CEQA Project: SCH# 2019029089

Lead Agency: County of Lake – Community Development Department Project Title: Harbin Hot Springs Resort (Heart Consciousness Church)

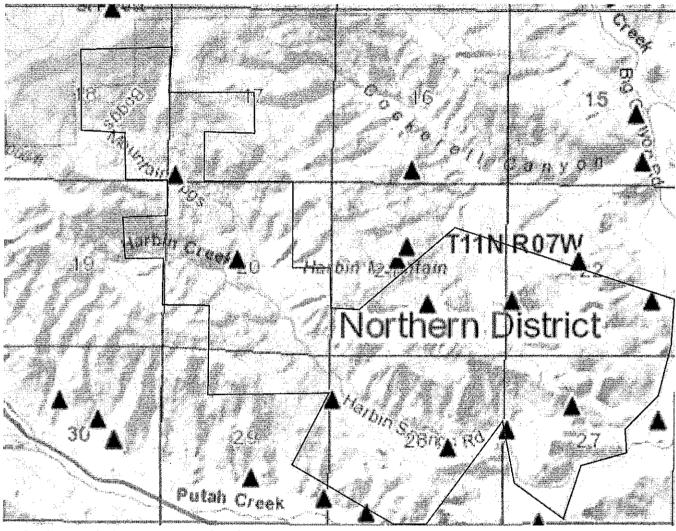
Division staff have reviewed the documents describing the proposed project area; ten known plugged and abandoned shallow geothermal temperature gradient wells are located within the proposed project area. The Well Location Map below shows these plugged and abandoned wells. A final letter was issued indicating the wells were abandoned to standard at that time. As these were shallow temperature gradient wells, a 1" to 1 ½" pipe was installed in the well to measure temperatures. Abandonment included the placing of a surface plug in the well bore and restoration of the well location. The ten wells are referred to as the "HS" 4, API#: 03390122, "HS" 6, API#: 03390124, "HS" 9, API#: 03390127, "HS" 12A, API#: 03390343, "HS" 17, API#: 03390717, "HS" 18, API#: 03390718, "HS" 20, API#: 03390354. The Division has conducted a
